# **SAFETY EVALUATION REPORT**

for the Nichols Ranch In Situ  
Recovery Project in Johnson and  
Campbell Counties, Wyoming  
Materials License No. SUA-1597

Docket No. 040-09067  
URANERZ ENERGY CORPORATION

**U.S. Nuclear Regulatory Commission**

Figure 3.1-1 Proposed Nichols Ranch Unit horizontal monitor wells

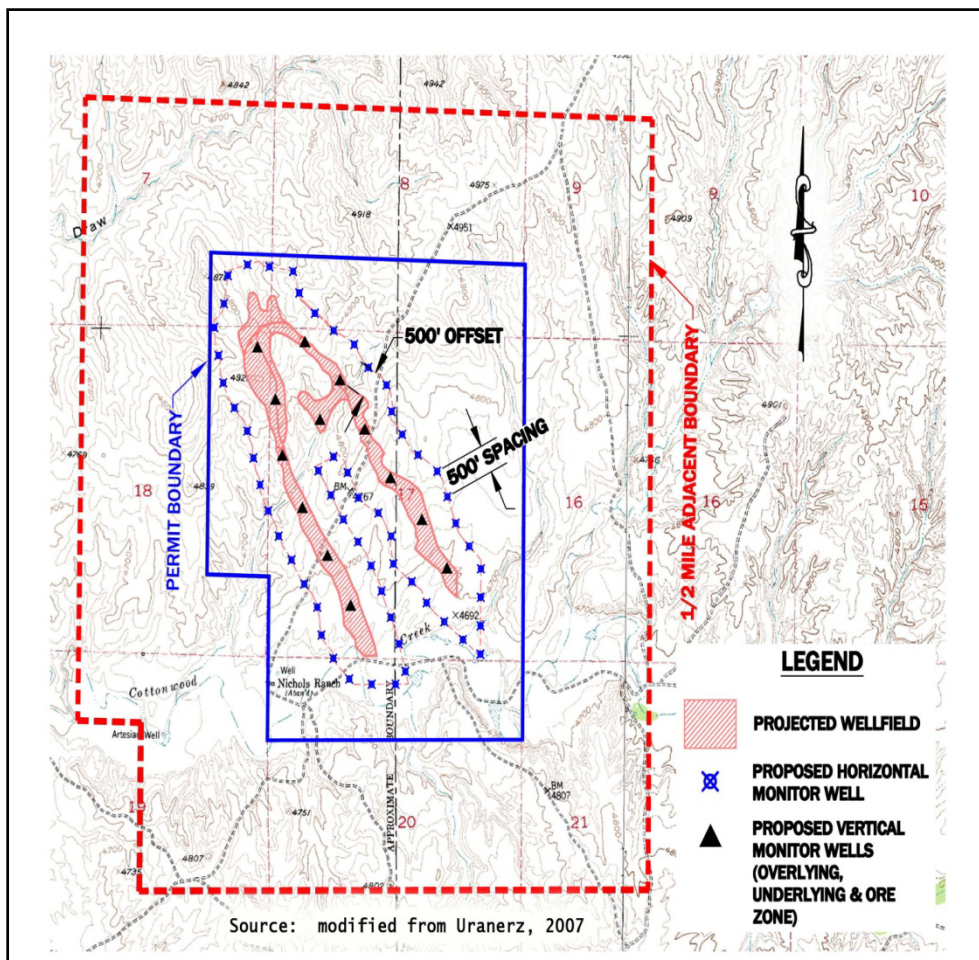
The applicant presented the modeled drawdown for the middle ore zone of Well Field #1 after 1 year of production at a bleed of 132.5 Lpm (35 gpm), as shown in Figure MPG 1-6 in the application. Drawdown for this layer was selected as the maximum anticipated drawdown because over half of the production comes from the middle ore zone. Drawdown is shown to be approximately 3.05 m (10 ft) at 3.2 km (2 mi) from the license boundary after 1 year. The applicant also presented the modeled drawdown for the middle ore zone of Well Field #2 after 3 years in Figure MPG 1-13 in the application. This timeframe includes 1.5 years for Well Field #1 and then 1.5 years of Well Field #2 production at a bleed of 132.5 Lpm (35 gpm). Drawdown for the middle ore zone was selected as the maximum anticipated drawdown because over half of the production comes from this layer. Drawdown is shown to be about 10.7 m (35 ft) at 3.2 km (2 mi) from the license boundary after 3 years.

In application Figure MPG 1-7, the applicant also presented the modeled potentiometric contours for the middle ore zone of Well Field #1 after 1 year of operation. The staff determined that the simulated contours demonstrated that an inward gradient is maintained to prevent excursions. The application also presented several potentiometric contours for both Well Field #1 and #2 at different times during production. These simulated contours also support the conclusion that an inward gradient would be maintained during anticipated production operations and during restoration operations that will have even greater consumptive use. Although the ground water modeling presented by the applicant is a simulation that generally represents the site conditions, the staff concludes that it is sufficient to demonstrate that an inward gradient is created by the proposed operating condition and can be maintained to prevent excursions. To support the ground water modeling predictions submitted by the applicant, the staff will impose a license condition, discussed in Section 5.7.8.4 of this SER, which requires the applicant to perform well field testing of the first production area in the Nichols Ranch Unit once the entire well field is installed and to provide the NRC staff with a report on the results for review and approval. The NRC staff will assess the report to determine if the field testing verifies the ground water flow modeling predictions showing that the inward gradient will be sufficient to prevent excursions under the proposed operating conditions.

The staff concludes that general ground water modeling at the Nichols Ranch Unit shows that an excursion could happen with an imbalance in production and extraction rates and spread over a large area. The applicant concluded that the excursion could be captured by reestablishing an inward gradient to reverse the ground water flow back into the well field. The modeling also indicated that an excursion will be detected and captured at the Nichols Ranch Unit within 60 days. Based on its review of the application, including modeling results and a commitment under a license condition to verifying this modeling by production area well field testing, the staff concludes that the applicant has adequately described its monitoring program, provided an initial demonstration that inward gradients will be maintained, and showed that the proposed monitoring well network will detect excursions in the Nichols Ranch Unit.

Figure 3.1-2 Proposed Hank Unit horizontal monitor wells

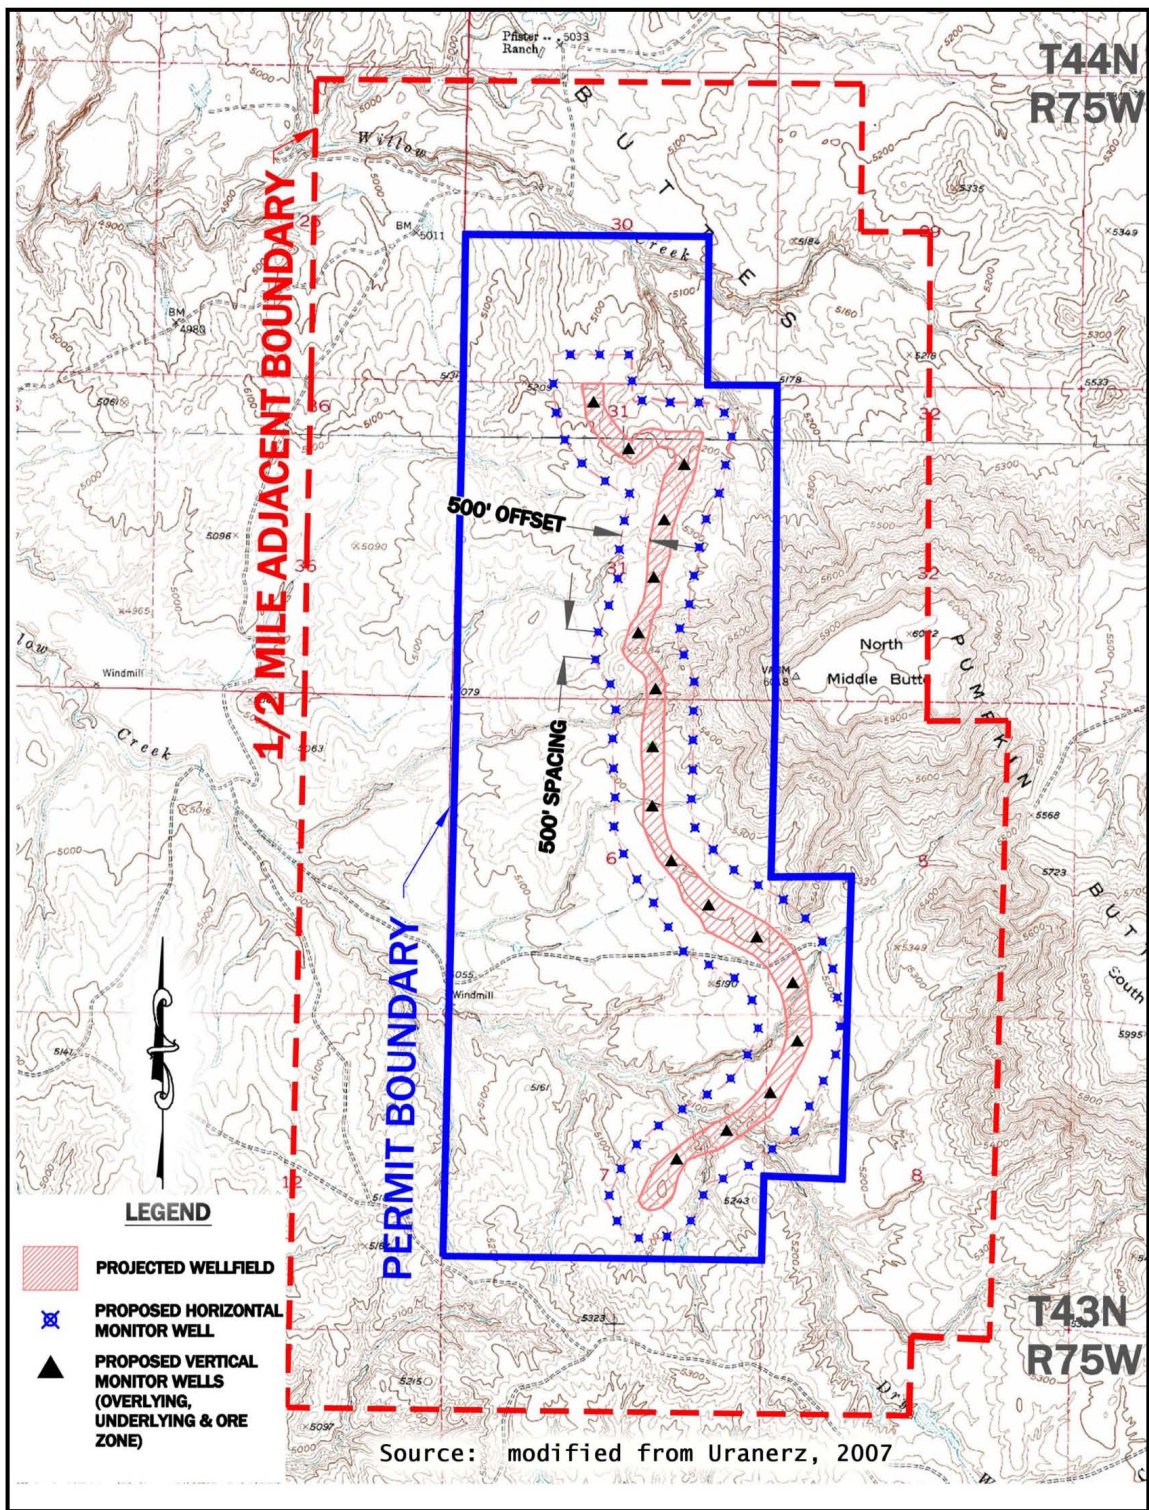
The applicant presented the modeled drawdown for the “F sand” ore zone in Well Field #1 after 1 year of production at 284 Lpm (75 gpm) in Figure MPH 1-5 in the application. The NRC staff finds that, on the downgradient west side of the ore body, a sufficient inward gradient is maintained with at least 1.52 m (5 ft) of drawdown extending out at least 61 m (200 ft). On the upgradient eastern side, however, the staff finds that the injection wells create three large areas

In Figure MPH 1-7 in the application, the applicant presented the modeled drawdown for the "F sand" ore zone in Well Field #2 after 1.5 years of production at 284 Lpm (75 gpm). The NRC staff finds that, for the downgradient west side of the ore body, a sufficient inward gradient is maintained with at least 1.52 m (5 ft) of drawdown extending out almost 305 m (1,000 ft). On the upgradient eastern side, however, the staff finds that the injection wells on the northern half create a large region of outward gradient as a consequence of the ground water mounding. Hydraulic heads in the ground water mounding areas range from 0 to -4.5 m (0 to -15 ft) over a distance of more than 305 m (1,000 ft) from the ore zone. These results are also reflected in the potentiometric head surfaces for the same simulation in Figure MPH 1-8. The staff concludes that this modeling exercise demonstrates that an outward gradient is created at the Hank Unit in this Well Field #2 operating scenario such that ground water is flowing away from the ore zone, which could potentially create an excursion. Similar to Well Field #1, the simulation is only an estimate of the possible flow for given production pattern and rates; however, the staff notes that the line-drive pattern, as presented in the model, could result in an outward gradient that may lead to well field excursions.

The NRC staff notes that localized dewatering and mounding behavior affects the pumping tests that are needed to show communication across the well field with the perimeter monitoring ring wells. The applicant stated that monitoring wells will be installed in the production zone in an example pattern shown in Figure 3.9 in the application. Excursion monitoring wells for each well field are located on a ring that is set 152 m (500 ft) from the nearest production well pattern, with 152 m (500 ft) between monitoring wells. Figure 3.1-2 shows the general location of perimeter monitoring wells for excursion detection monitoring at the Nichols Ranch Unit. The applicant provided analytical and ground water model simulations, which indicate that the cone of depression will reach the monitoring well ring at the Hank Unit under anticipated operating scenarios, as described above, except where an outward gradient is present. Although staff accepts the use of modeling to make an initial assessment of connectivity, the staff concludes that to verify the modeling, which indicates wells installed in the well field are in communication with the monitoring well ring, the applicant must conduct field pumping tests.

The staff finds that the steep drawdown and limited areal extent of drawdown created by pumping in the unconfined (unsaturated) "F sand" aquifer will require a unique pumping test strategy to ensure that the well field is in communication with the monitoring well ring. Such pumping tests will need to be conducted when the well fields are installed, as part of the hydrologic data collection for each well field. By license condition, the applicant will be required to submit these pumping tests for the first production areas in both the Nichols Ranch and Hank Units to the NRC for review and approval and also to submit other production area tests to the NRC for review. Section 5.7.8.4 of this SER discusses this license condition. The applicant indicated that it would require at least three pumping tests to establish communication with observation wells 305 m (1,000 ft) distant. The staff notes that a 5-day multiwell pumping test conducted by the applicant at URZHF-5 at 15.2 Lpm (4 gpm) in the Hank Unit did not create a response at observation wells located 152 and 305 m (500 and 1,000 ft) distant. Therefore, to demonstrate the effectiveness of the proposed monitoring well spacing, the applicant committed

in response 3.1.9 to open issues dated February 24, 2010 (Uranerz, 2010c), to present a pumping test strategy to the NRC for approval before conducting the well pumping test, as stated in application Section 5.7.8.4.
